Proposed changes as follows:

Create paragraph 4.5.1 n. and Figure 7-4-4:

Figure 7-4-4 Pile posting above ground with resistance to transverse loads.

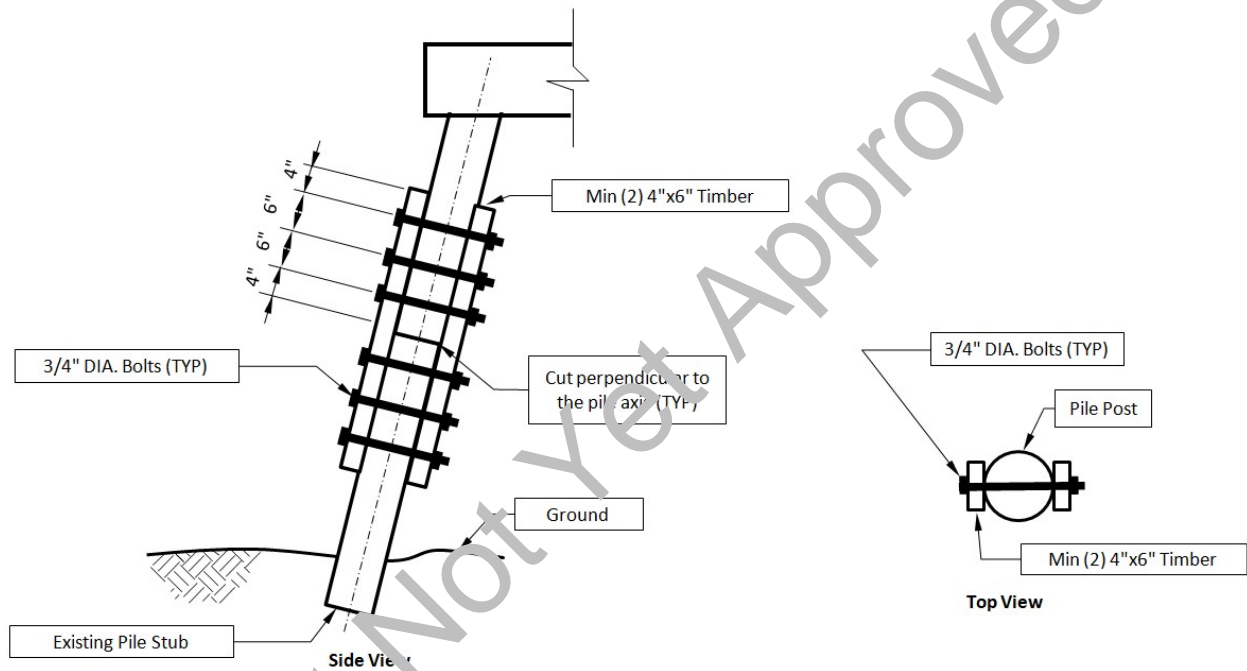
- n. A pile with above ground decay where the connection requires resistance to transverse loads may be posted as shown in Figure 7-4-4.
